Re: FirstLight Hydro Generating Company, Turners Falls Hydroelectric Project (FERC No. 1889) and Northfield Mountain Pumped Storage Project (FERC No. 2485).
Response to Comments

Study No. 3.3.1 Instream Flow Studies in Bypass Channel and below Cabot Station

Northfield Mountain Pumped Storage Project (No. 2485) and Turners Falls Hydroelectric Project (No. 1889)
Study Reports Comments and Responses

Attachment B: Vernon Discharge + Ashuelot River + Millers River in 2015 and 2016

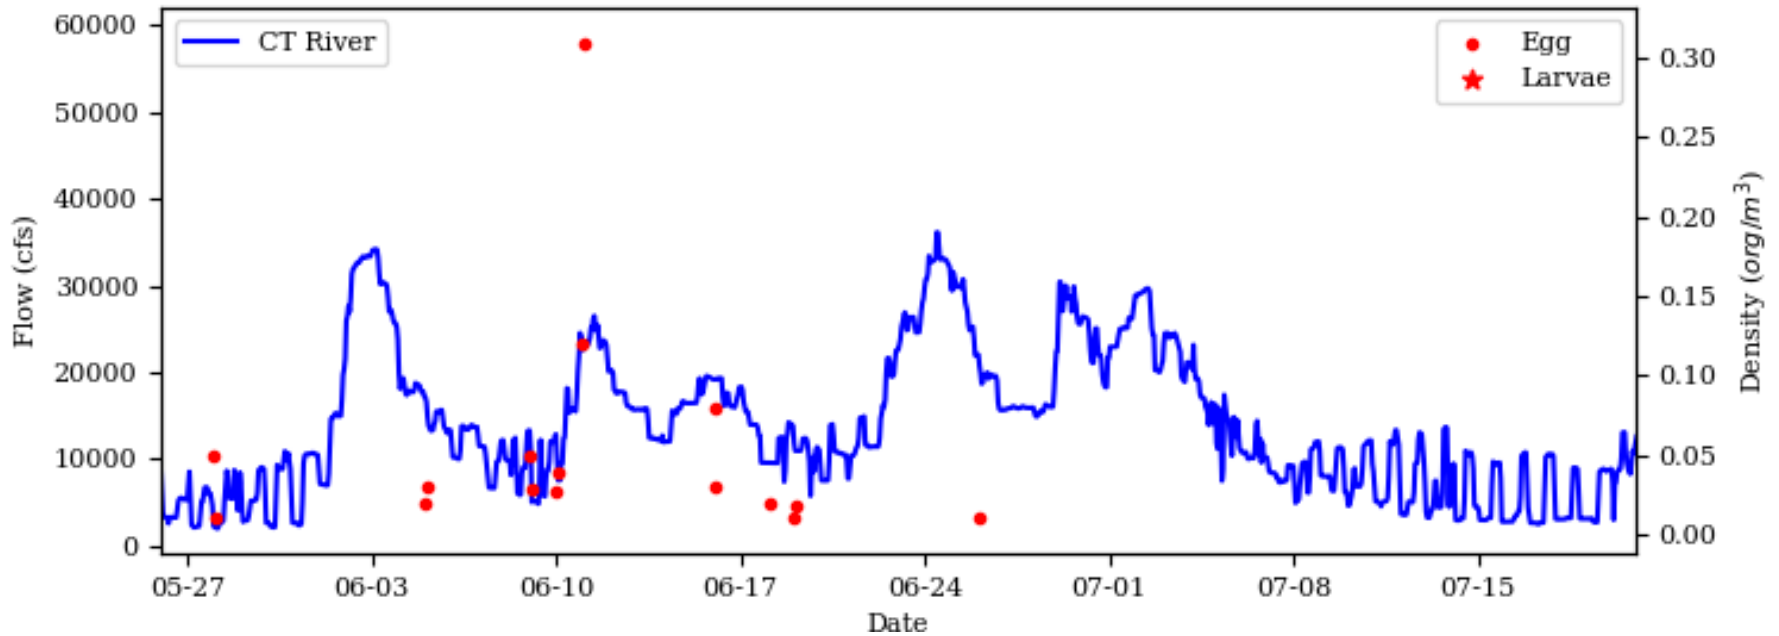
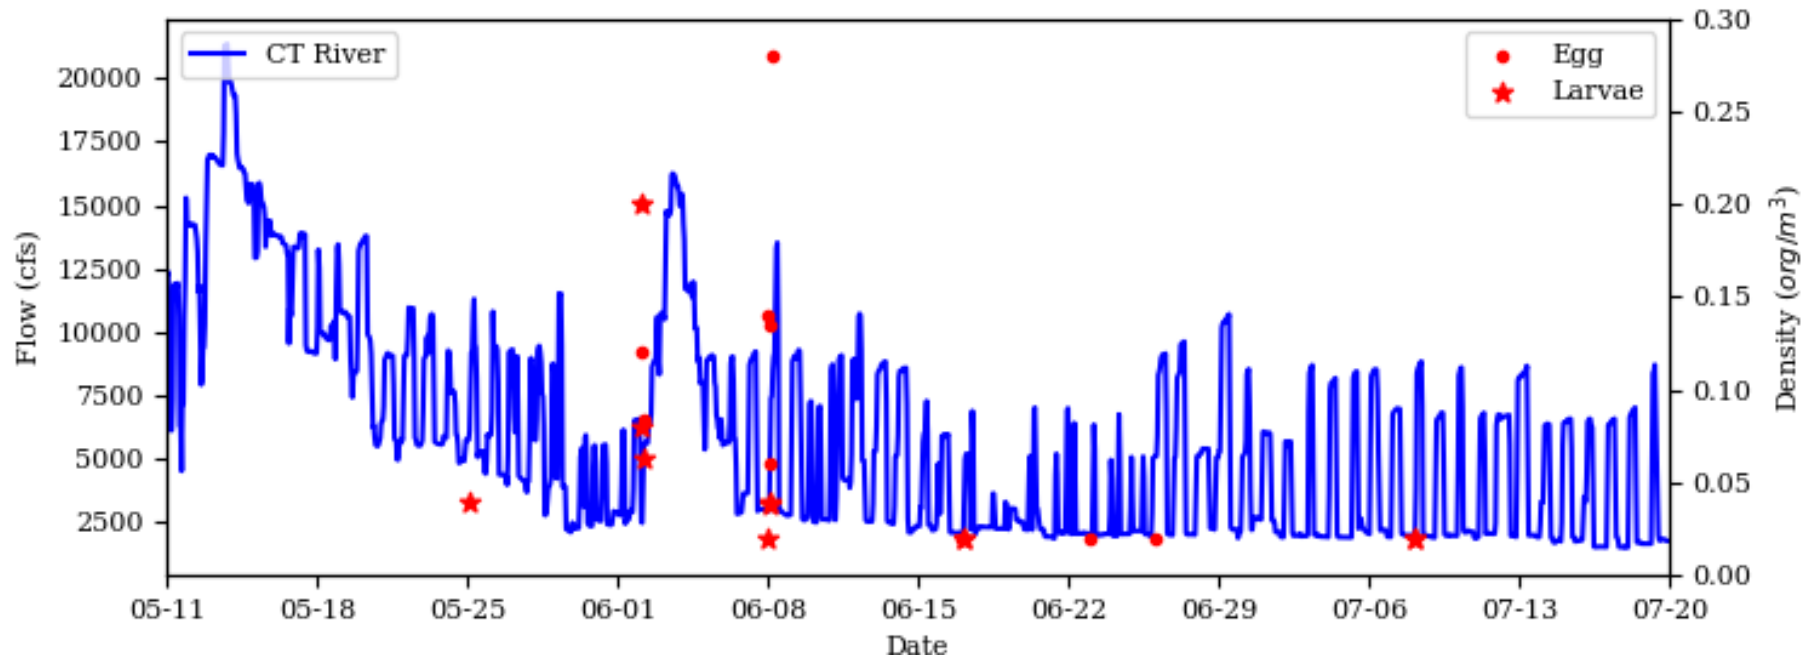
Life stage	Year	Organisms Entrained																																																						
Eggs	2015	6,811,199																																																						
Larvae (captured during offshore sampling)	2015	324,194																																																						
Eggs	2016	9,540,205																																																						
Larvae	2016	5,175,833																																																						
USFWS-14	Recommendations: We reiterate our request that FL should include river discharge (based on the combined discharges from the Vernon Project, the Ashuelot River, and the Millers River) when analyzing the 2015 and 2016 data to determine if a relationship exists between ichthyoplankton entrainment and river flow. Further, the analysis should not be based on average daily flow; instead, we recommend using hourly flows to correlate flows that were occurring during the time the ichthyoplankton samples were being collected.	See USFWS-11 for sample densities superimposed onto the hydrographs for 2015 and 2016. Sample densities were matched with the inflow to the TFI (Vernon + Ashuelot + Millers) within the hour the sample started for 2015 and 2016, and a series of figures showing correlation between flow and densities were produced. The first figure (see 3.3.20 Attachment D , Figure 1) shows organism density as a function of pump rate. Note that there does not appear to be a correlation between sample density and hourly flow rate. We also plotted organism density as a function of the ratio of NFM to Connecticut River flow (see 3.3.20 Attachment D , Figure 2). Note, there does not appear to be a relationship between the ratio of NFM to Connecticut River flow and organism density. Even when NFM is pumping at a flow up to 7 times more than what is available in the Connecticut River, entrainment densities do not increase. Entrainment density is a function of time of year and the current spawning activities in the Turners Falls Impoundment at Stebbins Island just downstream of Vernon Dam, and is not a function of operations at Northfield Mountain.

Commenter	Comment	Response					
		28	0	0	17,431	34,862	
		29	0	0	0	0	
		30	0	0	0	0	
NMFS-2	The Connecticut River discharge used in the model should combined discharges from the Vernon project, Miller River (USGS # 01166500) and Ashuelot River (USGS # 01161000).	See USFWS-3					
MDFW-1	The Division agrees with and fully supports the analysis, comments, and recommendations of the US Fish and Wildlife Service as expressed in their letter of November 23, 2018.	See USFWS-1, USFWS-2 and USFWS-3.

Attachment D: Organism Density as a Function of Pumping Rate (2015 and 2016)

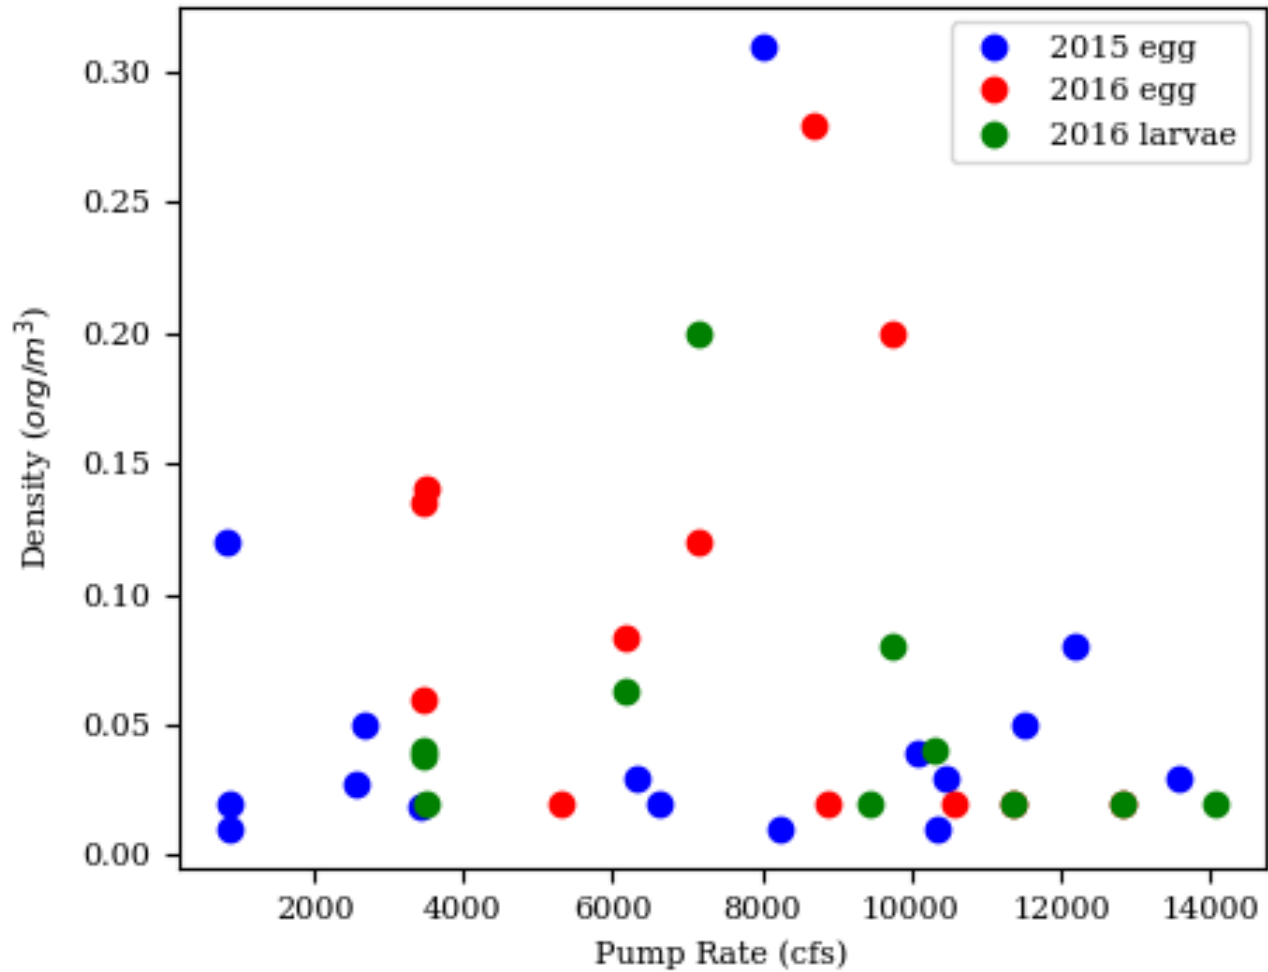
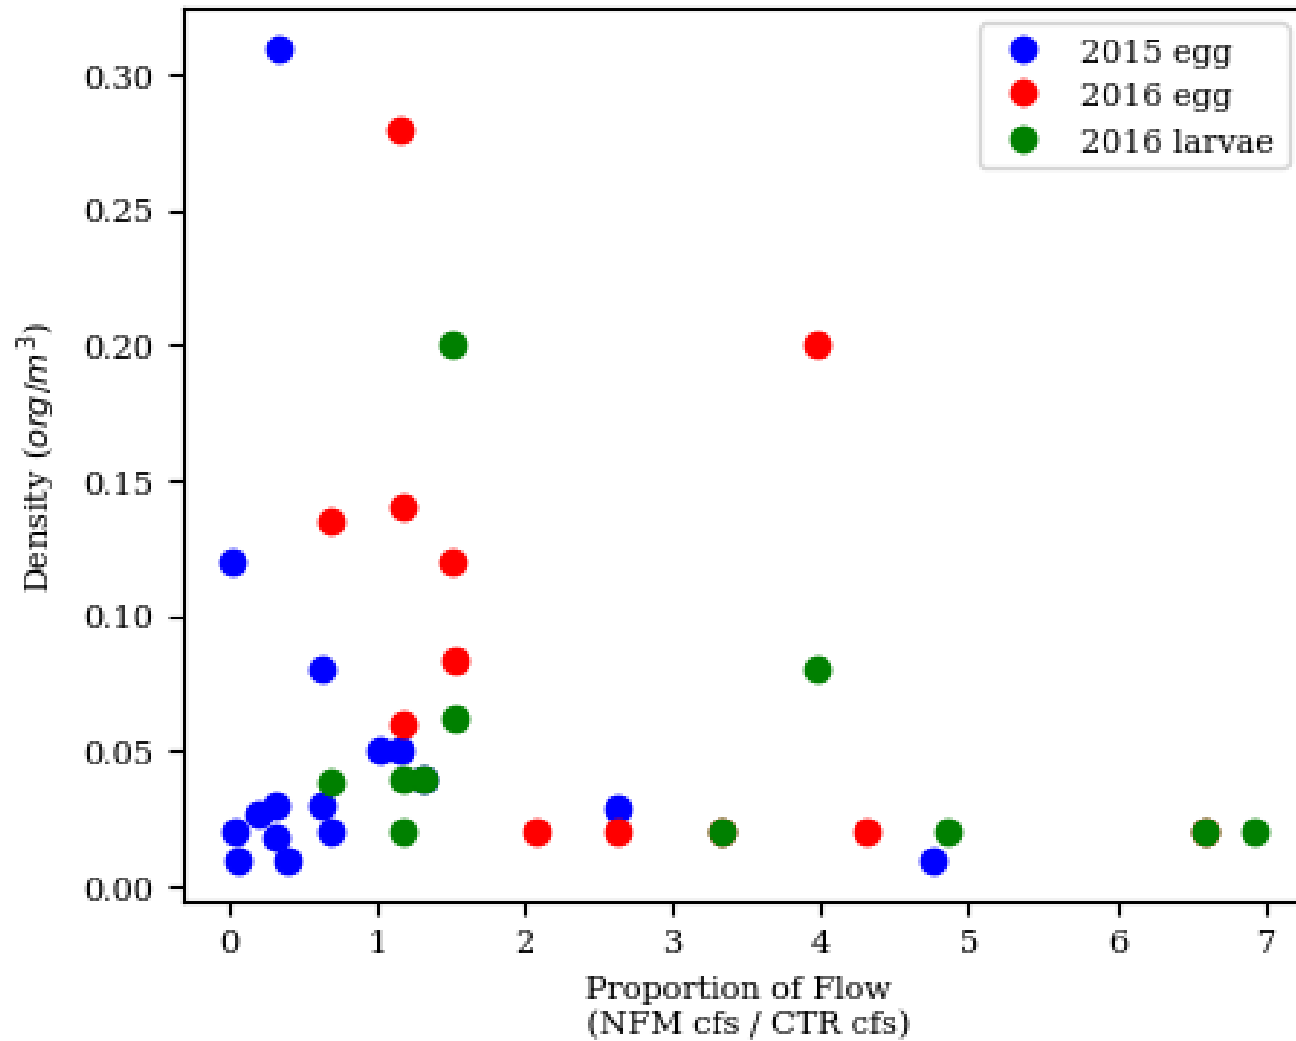
USFWS-5	Only 13 percent (n=6) of entrainment samples were collected when all four units were pumping. This small sample size makes it difficult to assess a potential relationship between entrainment density and number of units pumping. Under expanded operations, it is reasonable to assume more units will be operating more frequently; therefore, it is important to understand if a relationship exists and what its implications might be. If (on a per unit volume of water basis) increasing the number of units pumping increases the density of entrained ichthyoplankton, that information needs to be incorporated into the model.	See Figures 1 and 2 in USFWS-14 (below). These figures matched the sample density with hourly flow. More units pumping will have a larger pumping rate (cfs) and a larger ratio of NFM to Connecticut River flow. There is no correlation between operations and entrainment densities. Entrainment is a function of the time of year and spawning conditions in the river. Therefore, more fish spawning in the river means higher entrainment.

USFWS-6	Flow data from the Montague USGS gage were used in assessing if a relationship existed between river flow and entrainment rate. As noted below, flows at the Montague gage are impacted by Cabot Station operations and may not be	See USFWS-14 (below).
